APPEAL SUMMARY

Appeal ID: 22157

Project Address: 5510 N Denver Ave

RECONSIDERATION OF APPEAL ID:
22001

L1 ARCHITECTURAL PLAN - WOOD
POST MARKUP

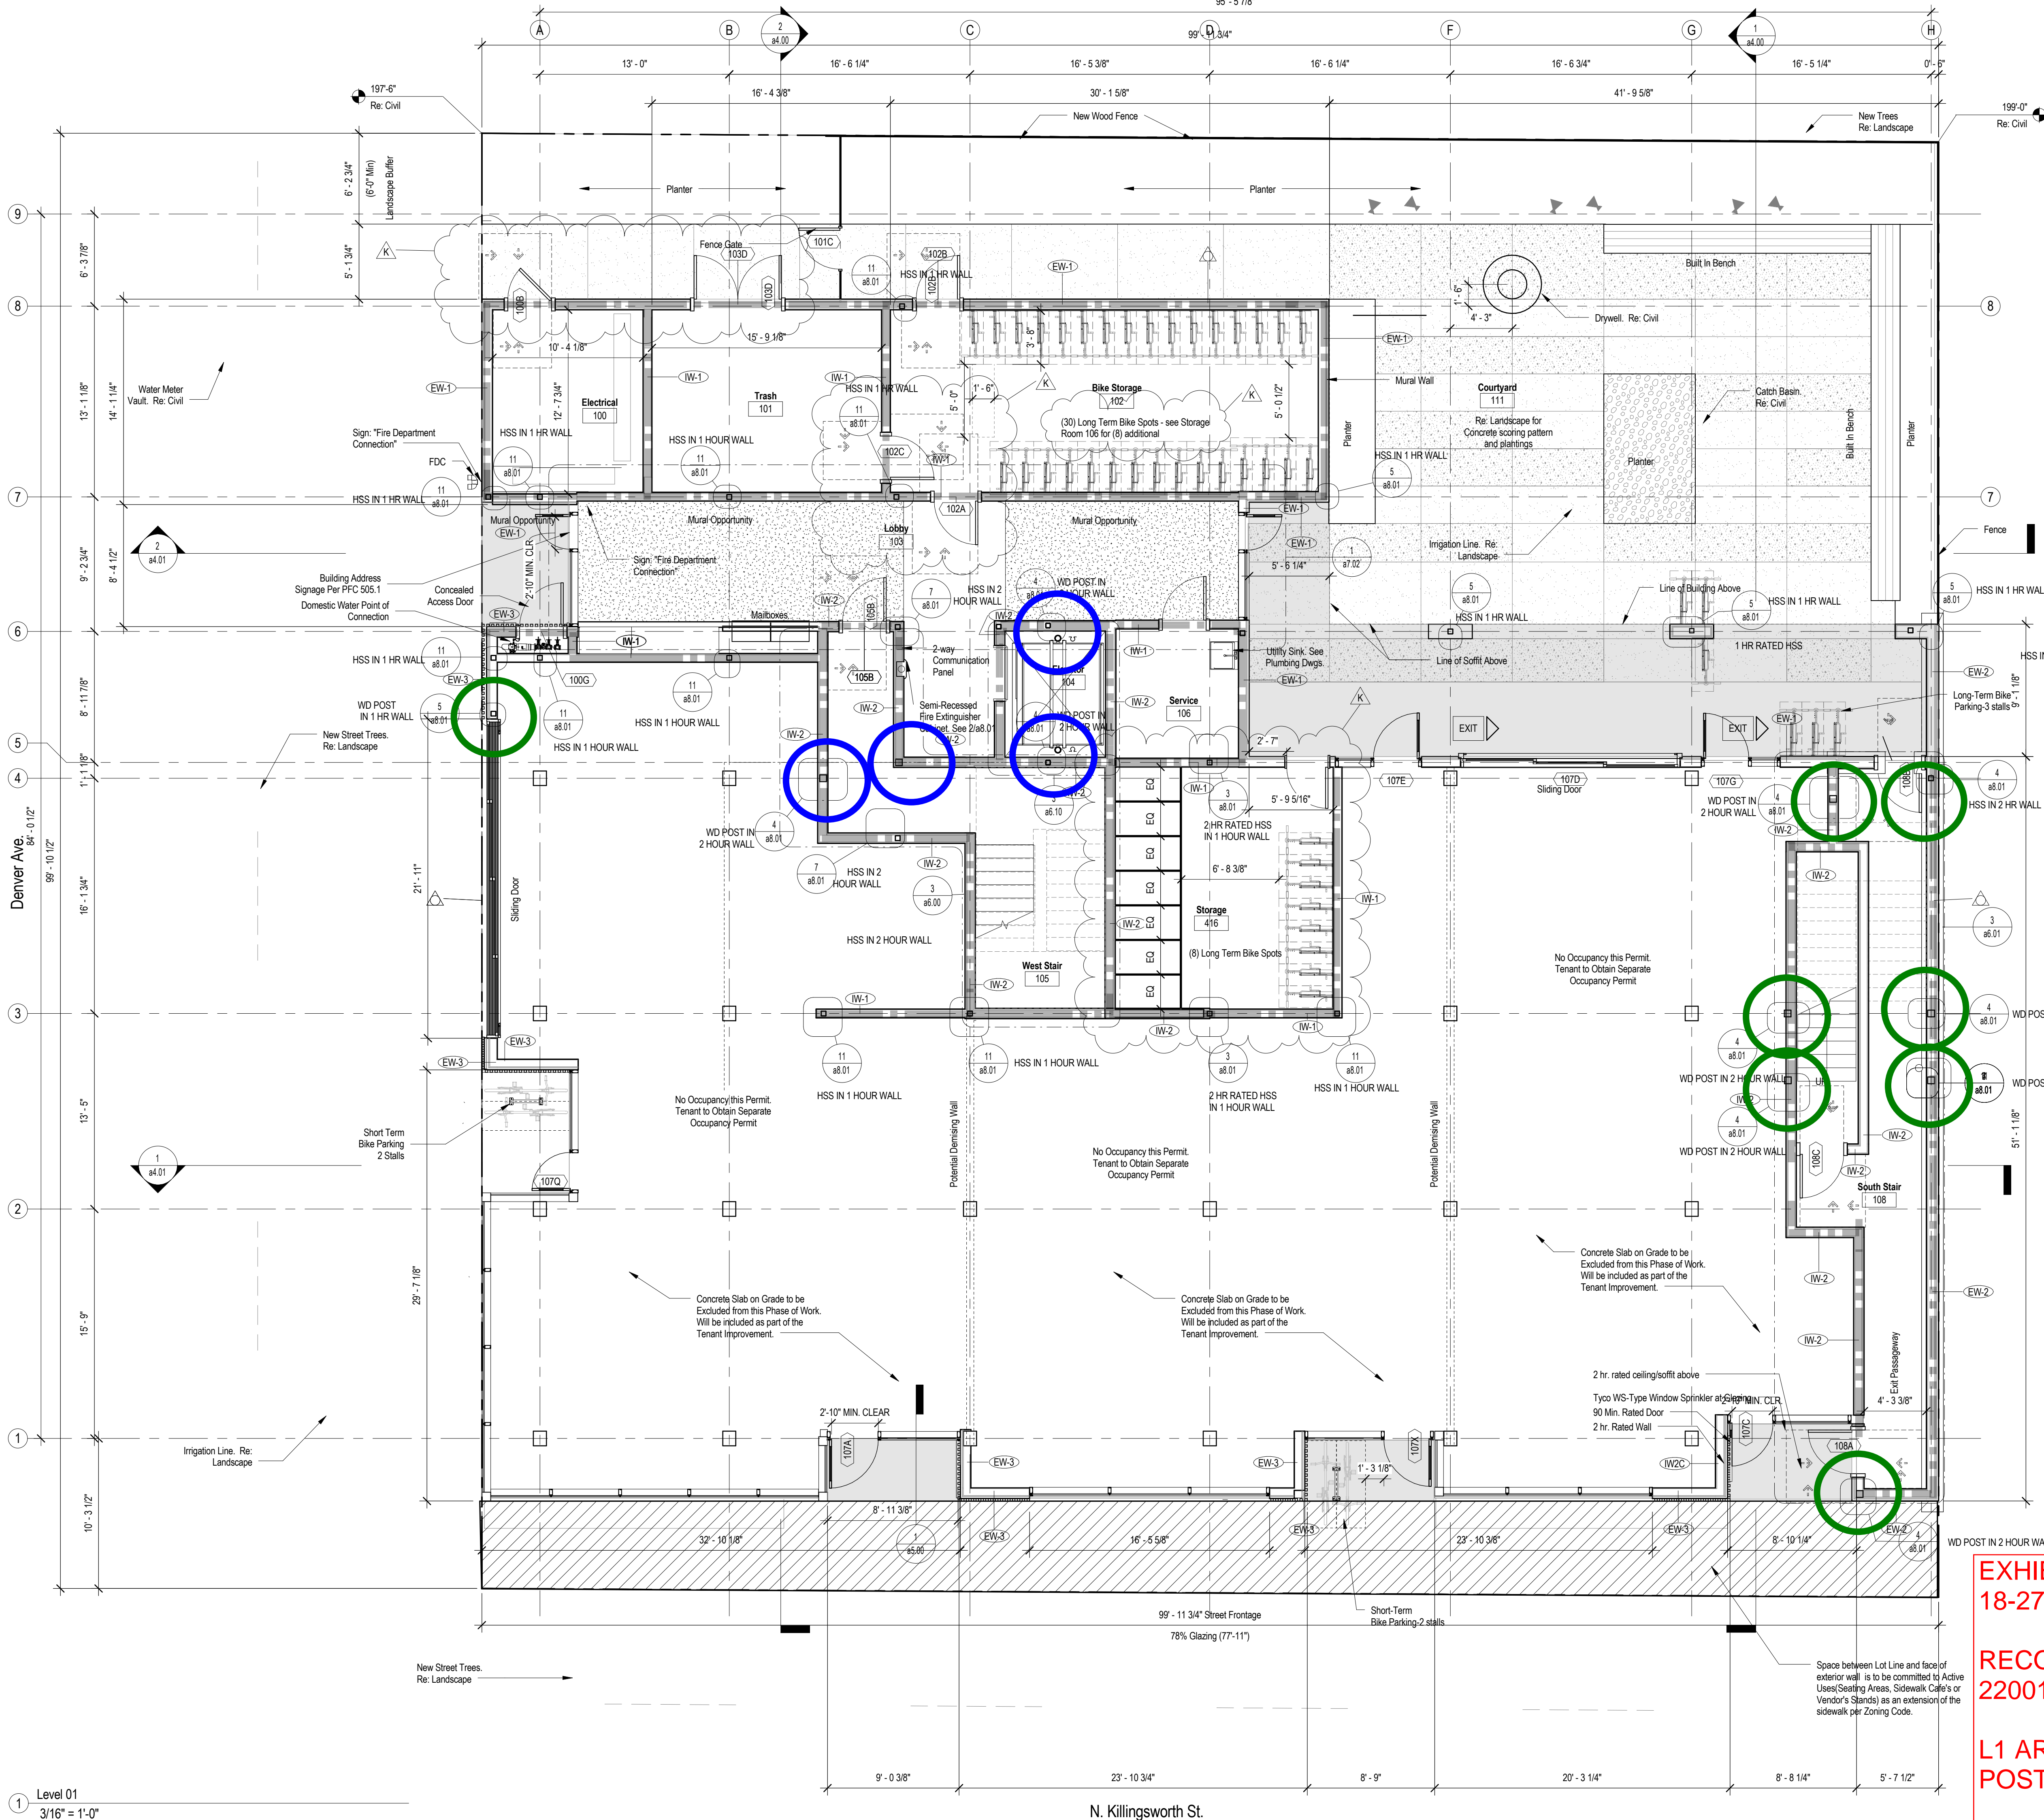
There are (2) conditions for the wood posts; with glu-lam beam above, and no beam above. Exhibits 1&2 show architectural and structural L1 plans with each a markup calling out the condition of each wood post, and referencing the details for head and base conditions.

WOOD POST WITHIN 2-HR FIRE-RATED WALL ASSEMBLY WITH GLULAM BEAM ABOVE:
REF DETAILS
12/ a8.01 (head) -EXHIBIT 3
12/s6.01 (base) - EXHIBIT 4

WOOD POST WITHIN 2-HR FIRE-RATED WALL ASSEMBLY WITH NO GLULAM BEAM ABOVE:
REF DETAILS
13/a8.01 (head) - EXHIBIT 3
12/s6.01 (base) -EXHIBIT 4

REFERENCE DETAIL 4/a8.01 ON EXHIBIT 3 FOR POST WITHIN 2-HR WALL FOR ALL MARKED UP POSTS

L1 STRUCTURAL PLAN - MARKUP

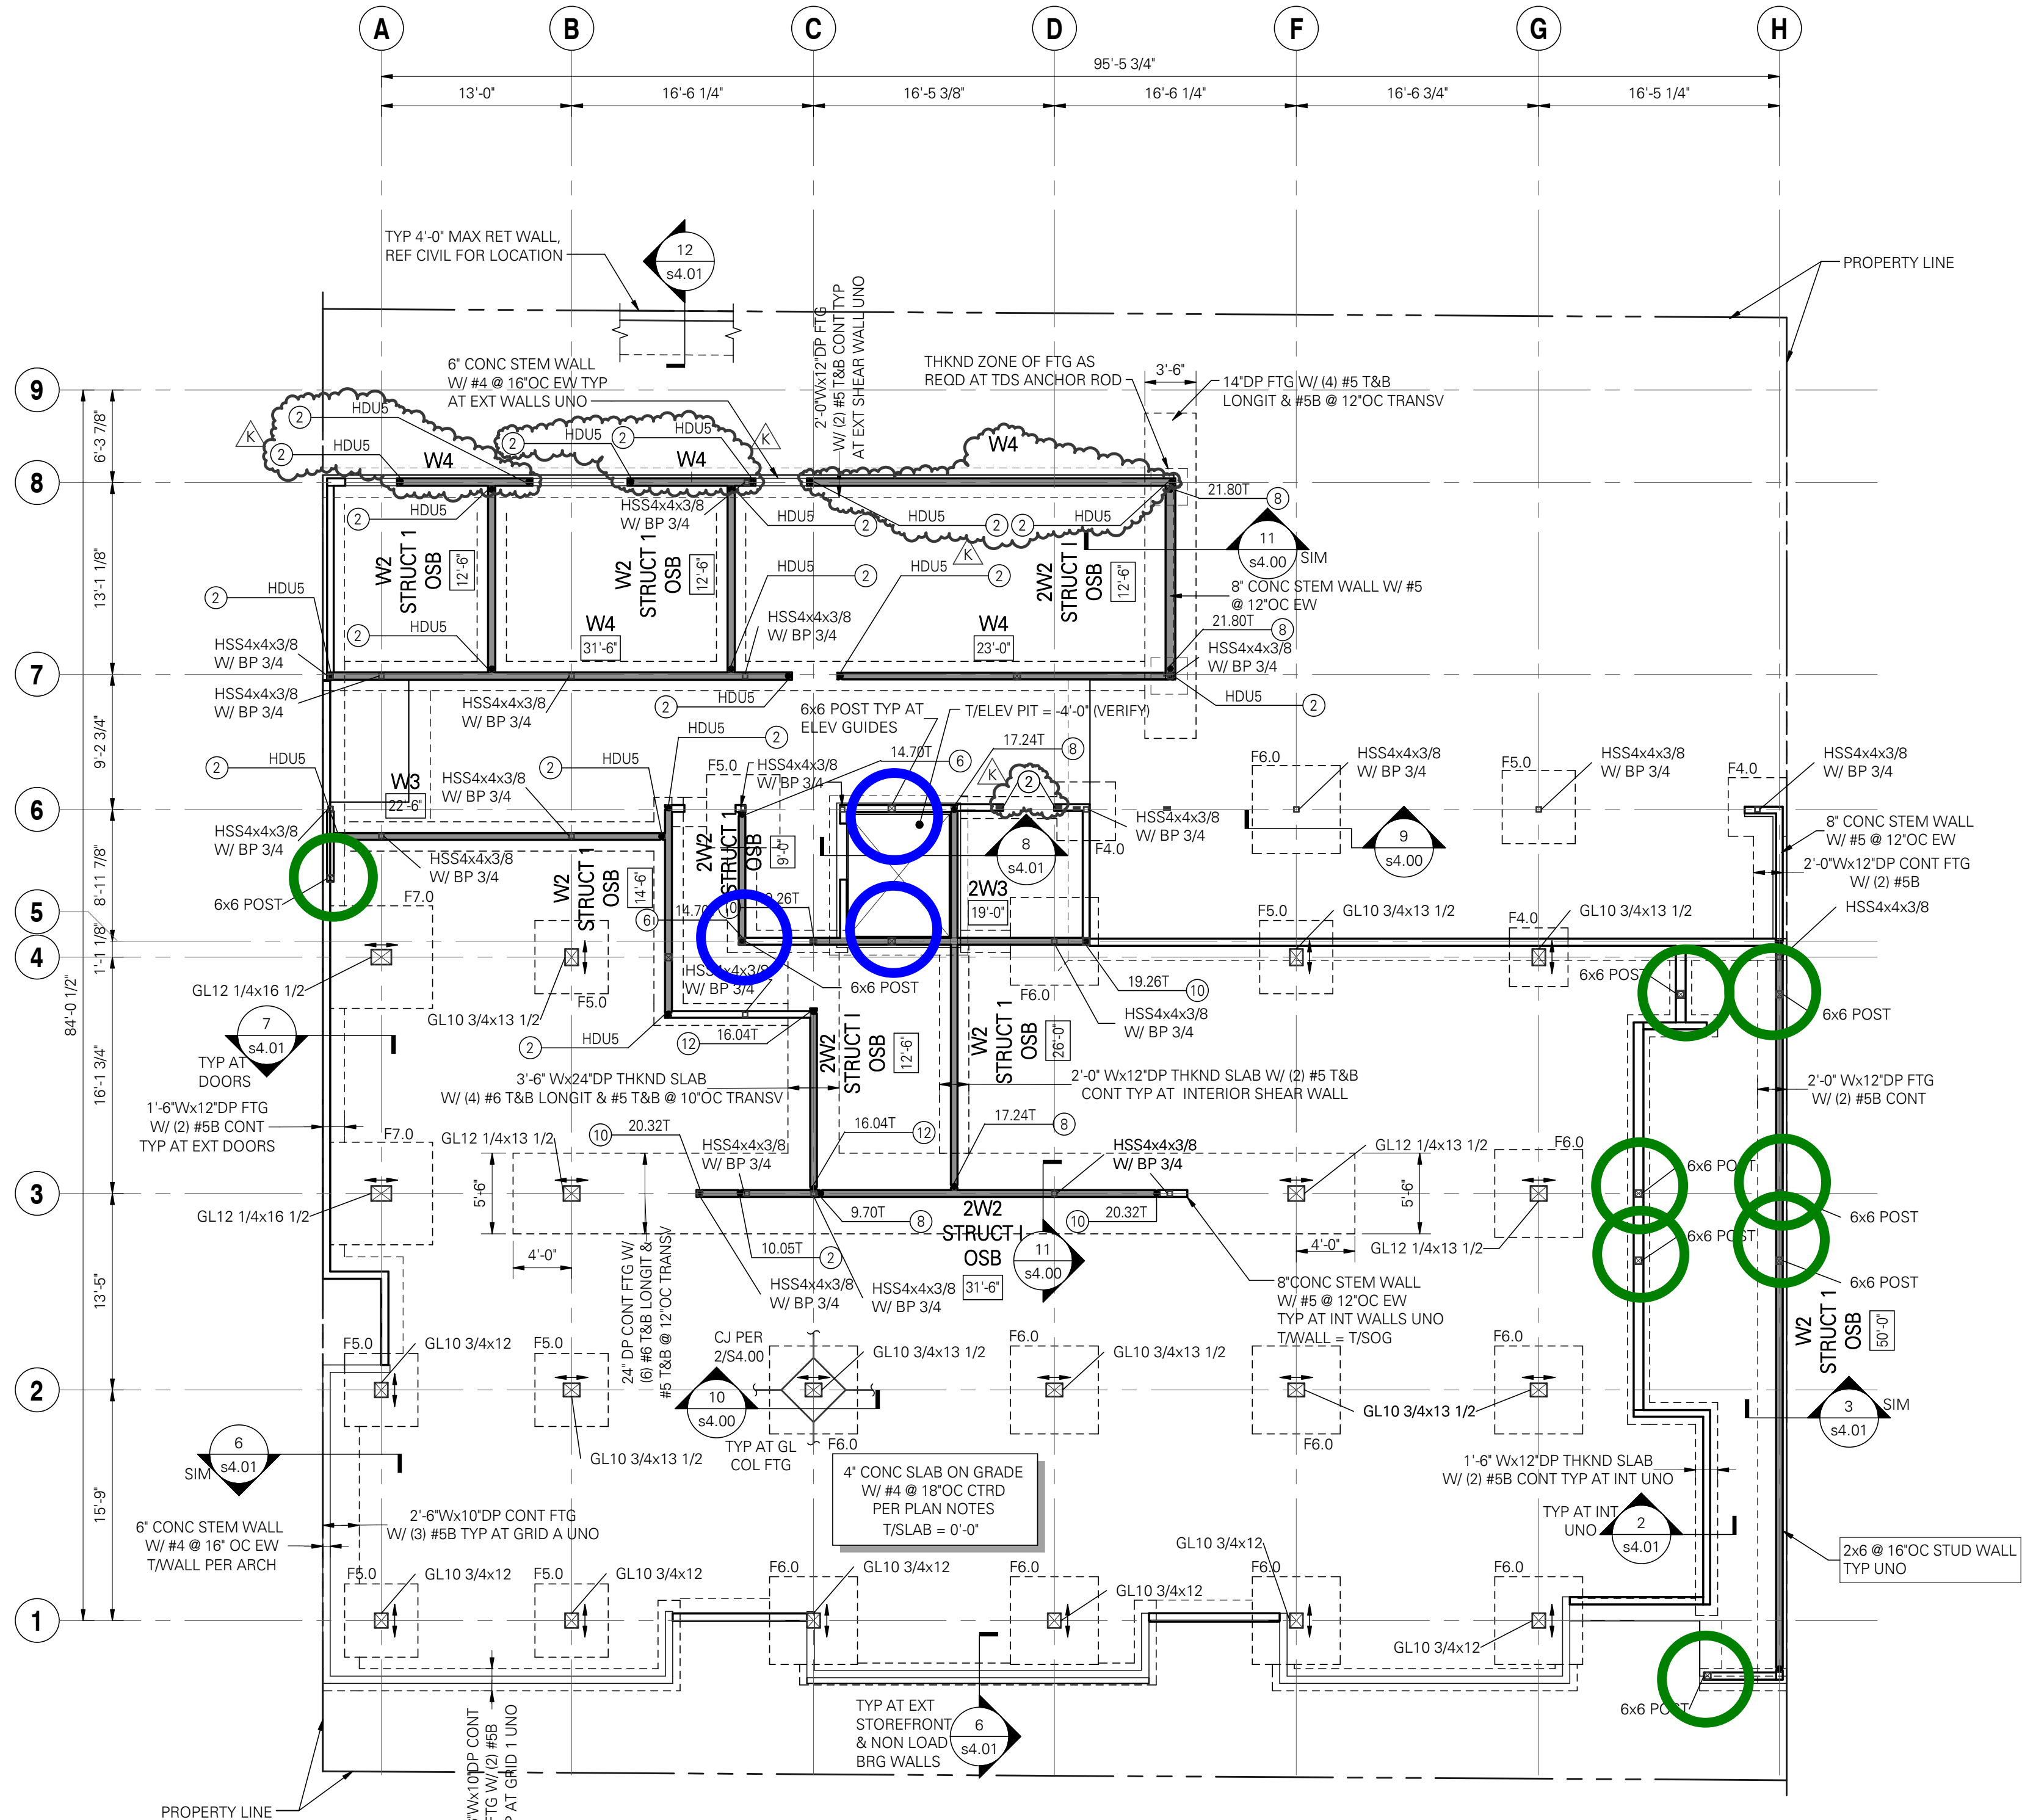
We were asked to demonstrate that the wood posts in both conditions meet the requirement that the column be completely within the top and bottom plate of the wall, and that the base plate is wood. The detail shown on 12/s6.01 on Exhibit 6 shows the base detail for both conditions. The post sits on a pressure-treated wood plate which sits fully within the wall.

WOOD POST WITHIN
FIRE-RATED WALL
ASSEMBLY WITH GLULAM
BEAM ABOVE:
REF DETAILS
12/ a8.01 (head) - EXHIBIT 3
12/s6.01 (base) - EXHIBIT 4

WOOD POST WITHIN
FIRE-RATED WALL
ASSEMBLY WITH NO
GLULAM BEAM ABOVE:
REF DETAILS
xxxxxx (head) - EXHIBIT 3
12/s6.01 (base) - EXHIBIT 4

REFERENCE DETAIL 4/a8.01 ON
EXHIBIT 3 FOR POST WITHIN 2-HR
WALL FOR ALL MARKED UP POSTS
